Project 94004.01  
8 November 2018  
R.001.Rev0  
MJJ

### **Proposed Access Ramp/Stairs and Deck Kunapipi Ski Lodge, Perisher Valley**

PROPOSED ALTERATIONS & ADDITIONS  
TO KUNAPIPI SKI CLUB LODGE, PERISHER  
VALLEY NSW - FOR KUNAPIPI SKI CLUB  
DEVELOPMENT APPLICATION - DA 2c

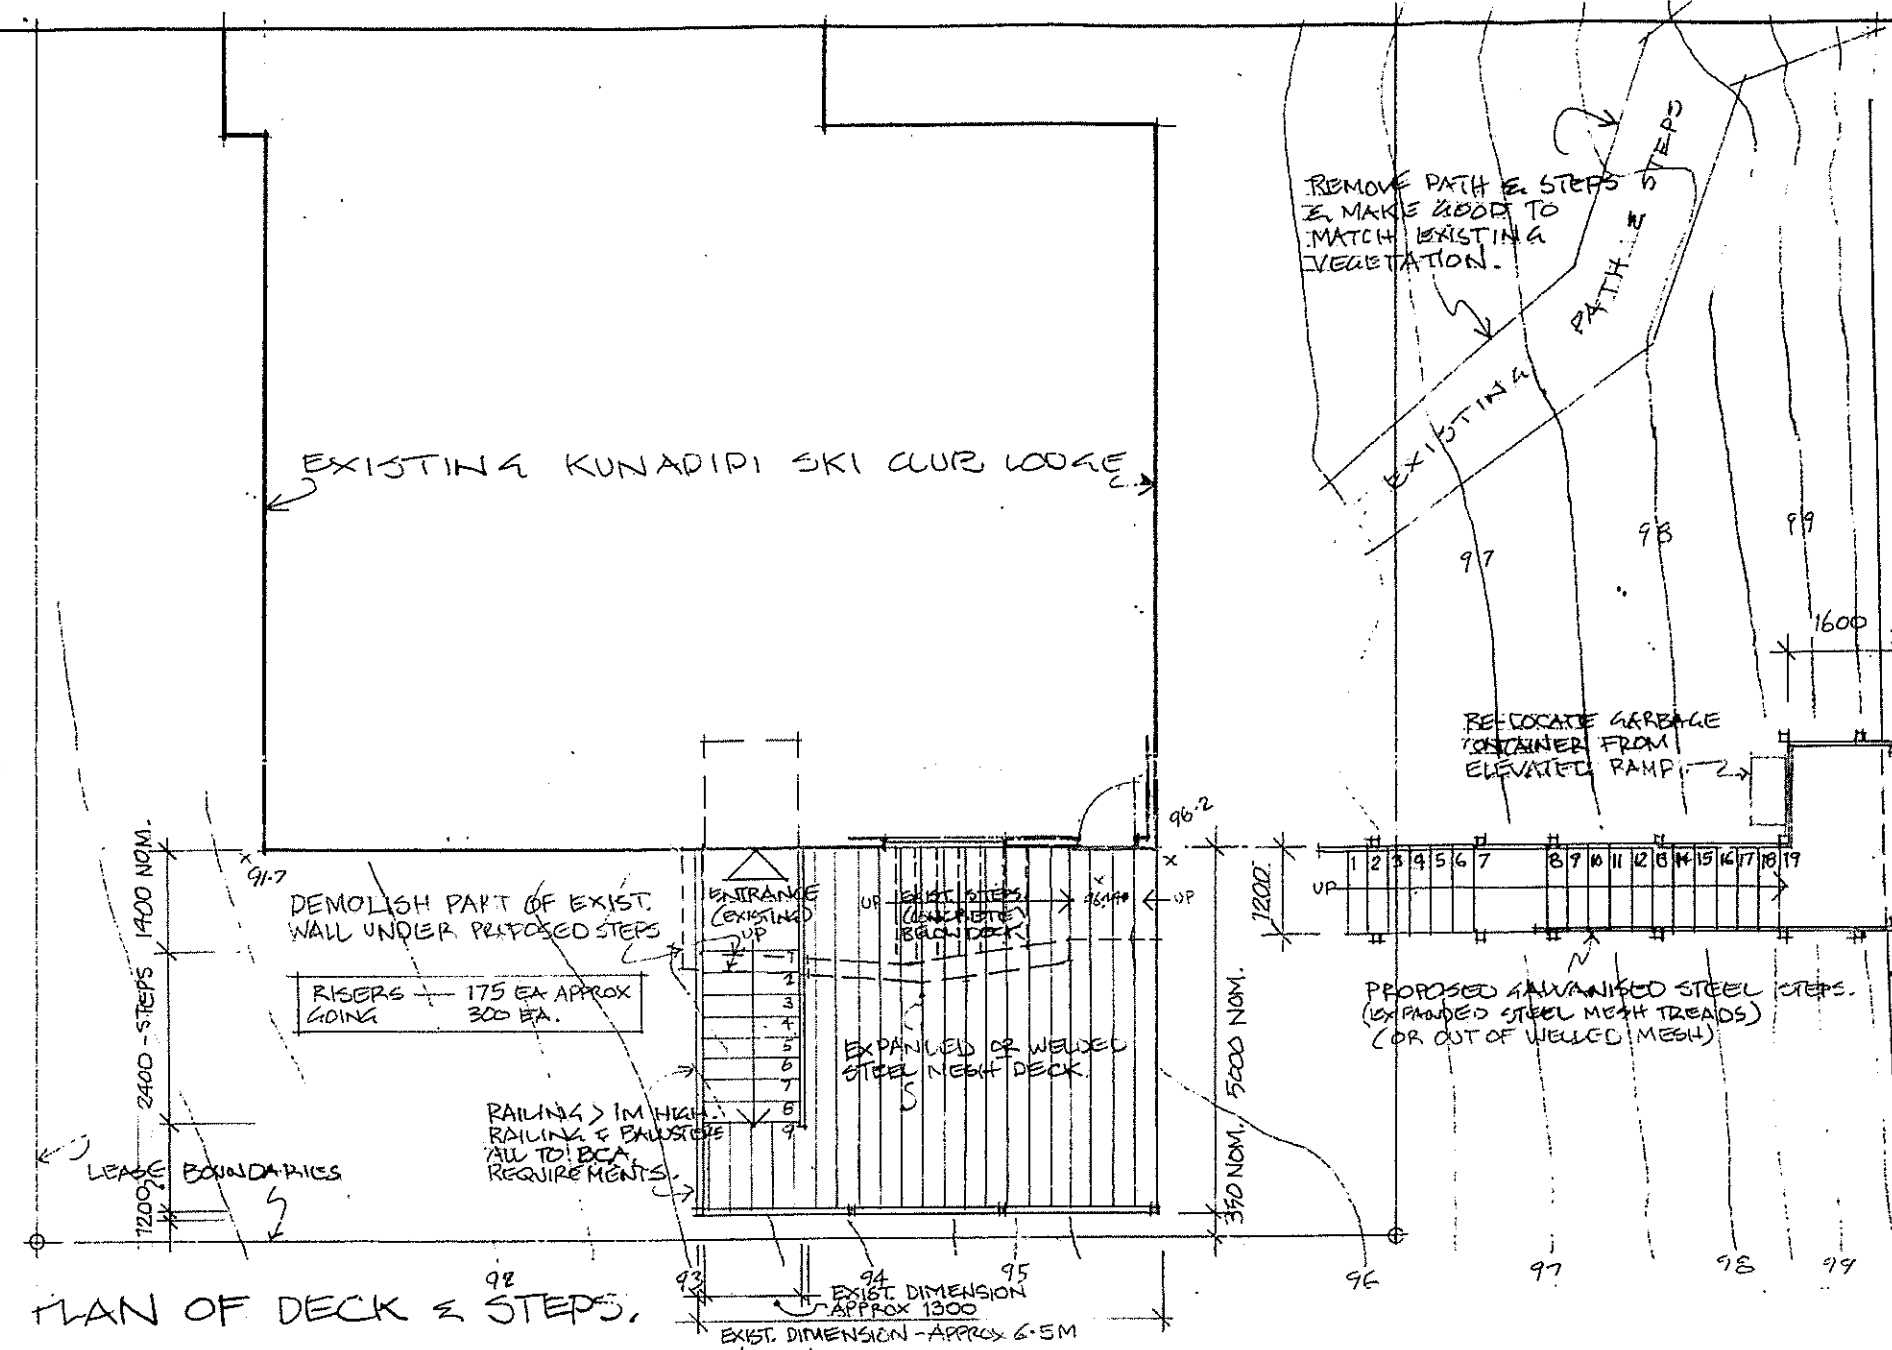
Site works as detailed on the Development Application DA 2C, drawing dated October 2018, prepared by Mark Cambourn and Associates Pty Ltd (see attached drawing) indicate that minimal site earthworks will be required and that the stairs and deck would be of galvanised steel similar to the stairs at the southern side of the lodge. The part of the existing stone wall to be demolished is retaining material for the steps and is above natural ground level and so no excavation into the existing hillside is expected. It has no stability implication of the hillside.

It is concluded that the revised proposed development will have minimal geotechnical impact on site conditions from a stability perspective, and that the hazard risk level will not be increased by the proposed new works.

We would recommend that all footings found within weathered rock and the excavations viewed by a Geotechnical Engineer to confirm the suitability of the founding stratum. Site surface drainage or any existing subsurface drainage systems must not be compromised by the proposed works.
